# CITY OF ALBUQUERQUE

**Re: Taco Cabana**  
**10200 Coors Blvd NW**  
**Traffic Circulation Layout**  
Architect's Stamp 03-13-17 (B13-D025)

Based upon the information provided in your submittal received 03-14-17, the above referenced plan cannot be approved for Building Permit until the following comments are addressed:

**D TCL Plan**  
Scale: 1" = 20'

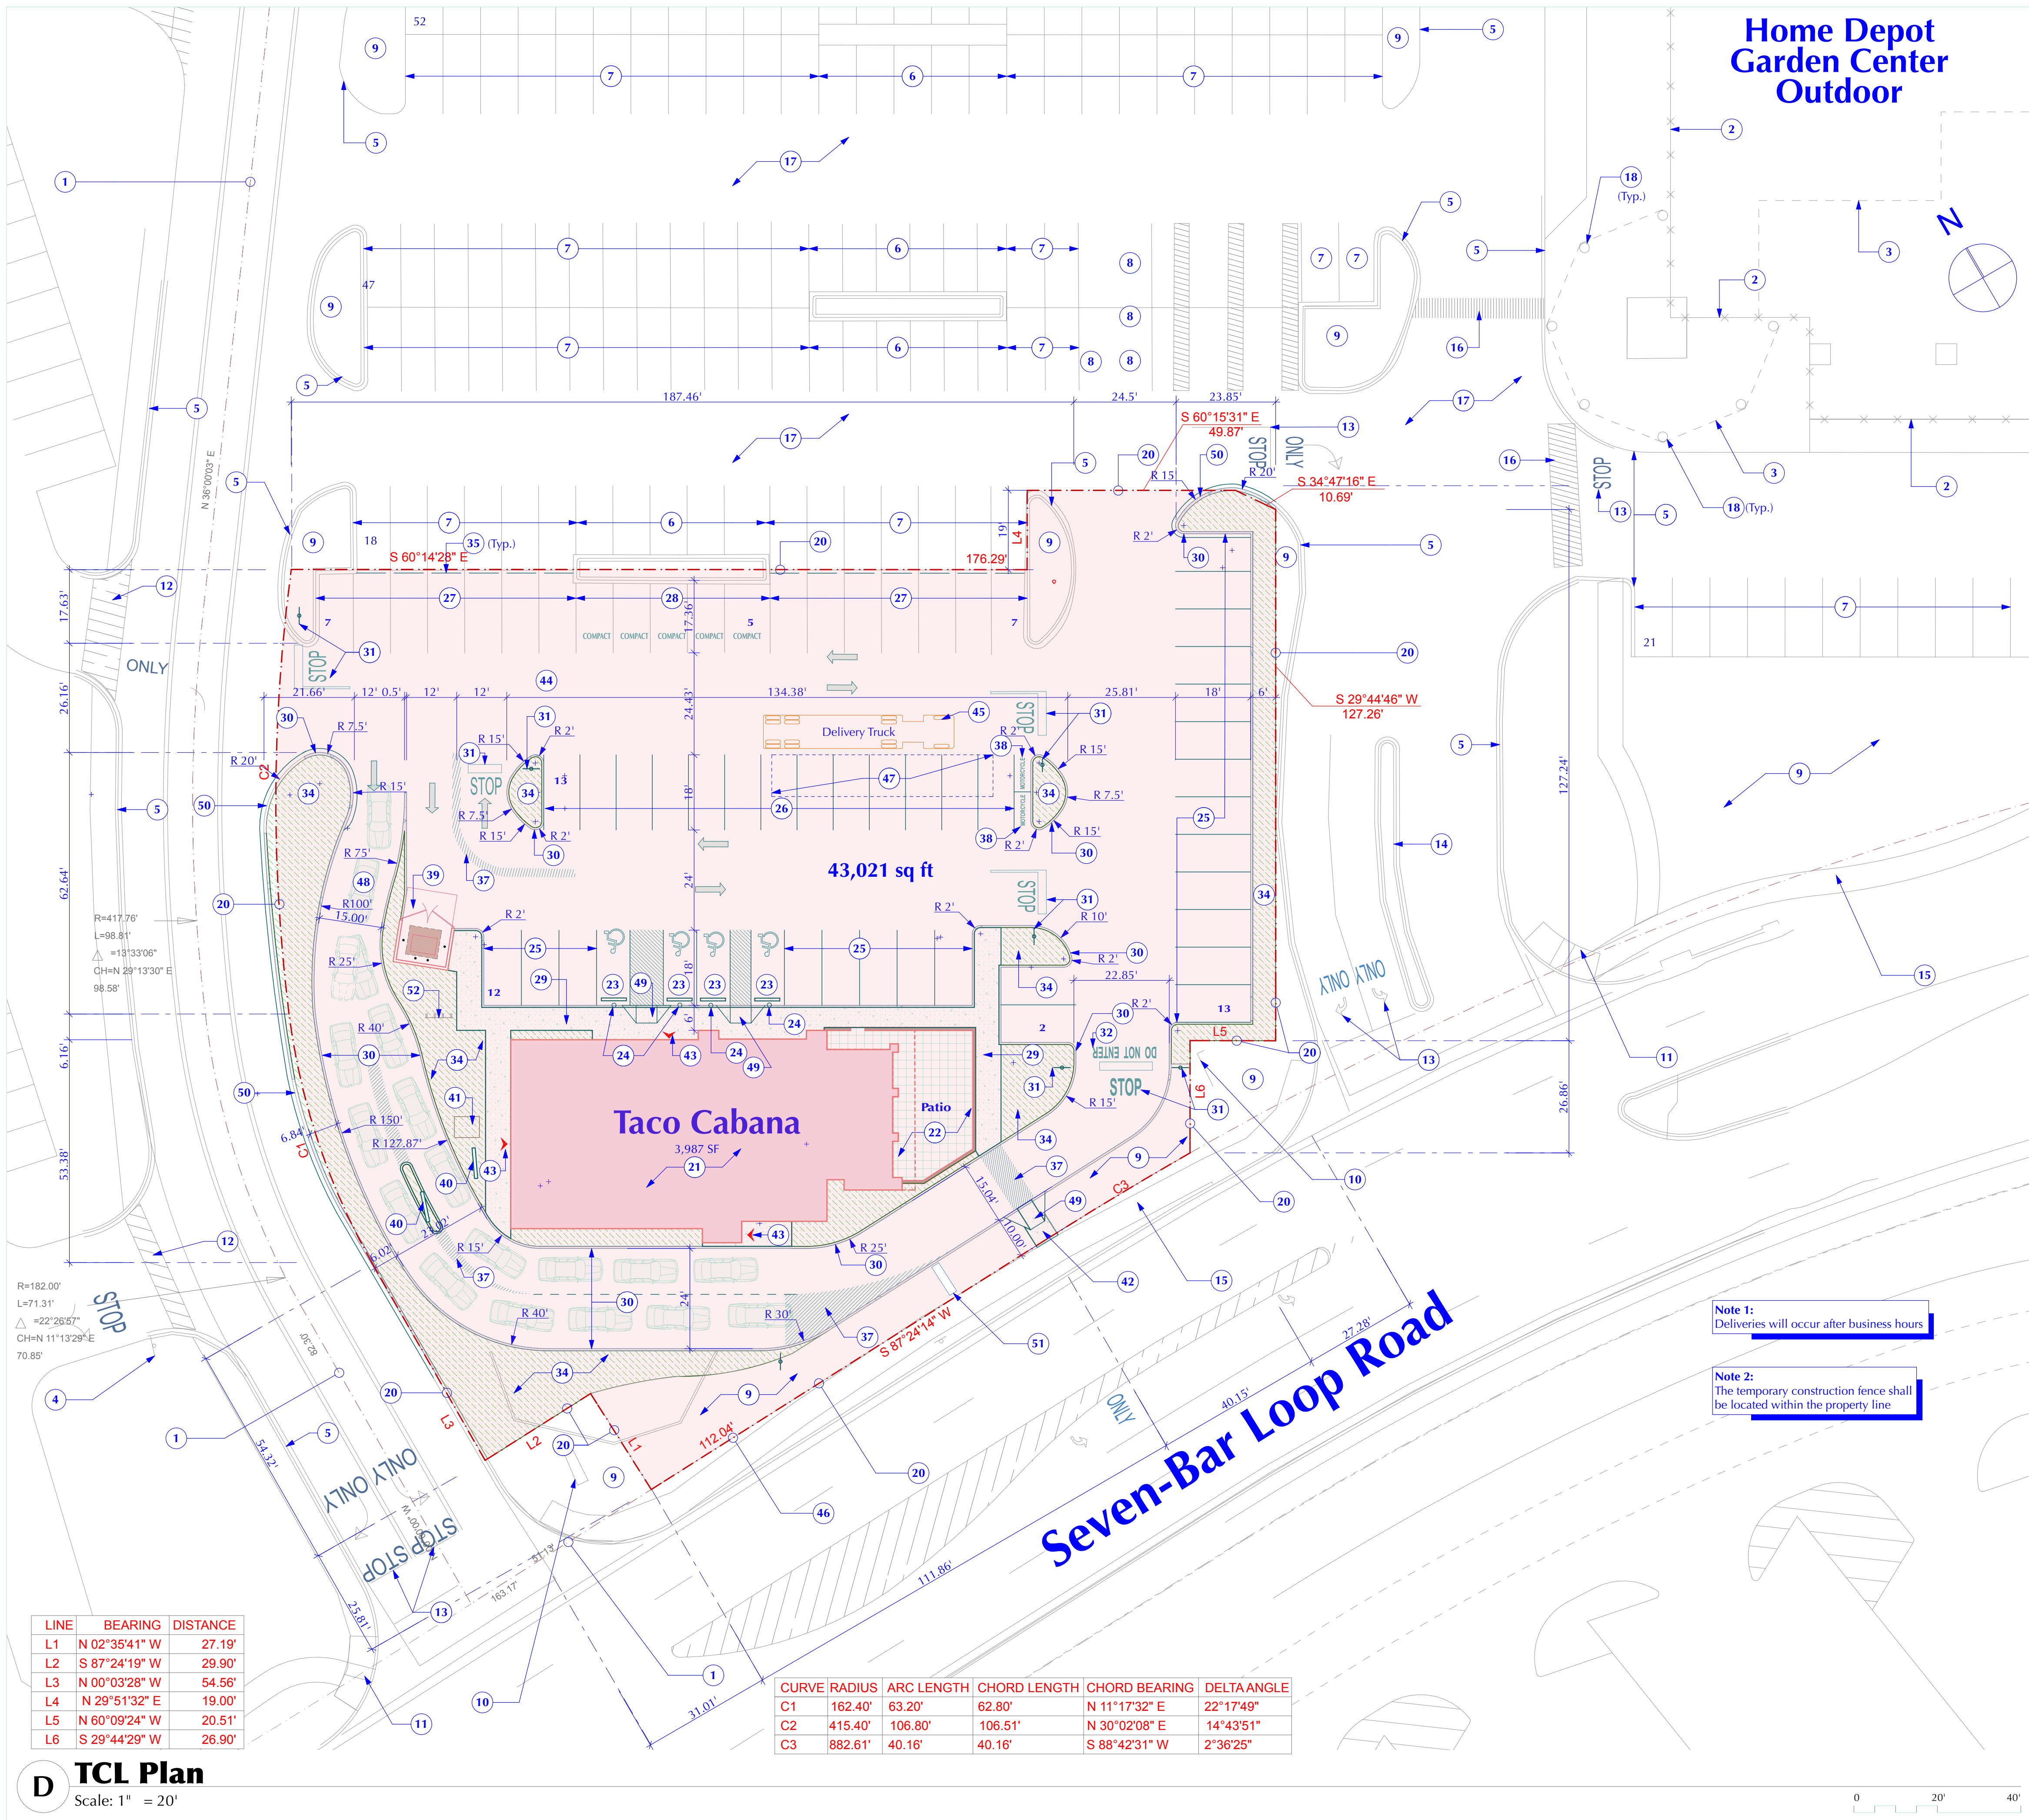
1. Per the zoning code, a 6 ft. wide ADA accessible pedestrian pathway is required from the public sidewalk to the building entrances. How will pedestrians in wheelchairs get to the building from the path? It looks like a ramp may be missing from the building side.
2. At the end of the Drive Through it is showing an isle of 22.85'. This should be 24' because of the parking on both sides and two-way traffic. You may consider shrinking the parking stalls on the east side to 16' allowing the cars to hang over the landscaping area by 2'.
3. The ADA curb ramps off 7 Bar Loop should be updated with Detectable Warning Surfaces or Truncated Domes.
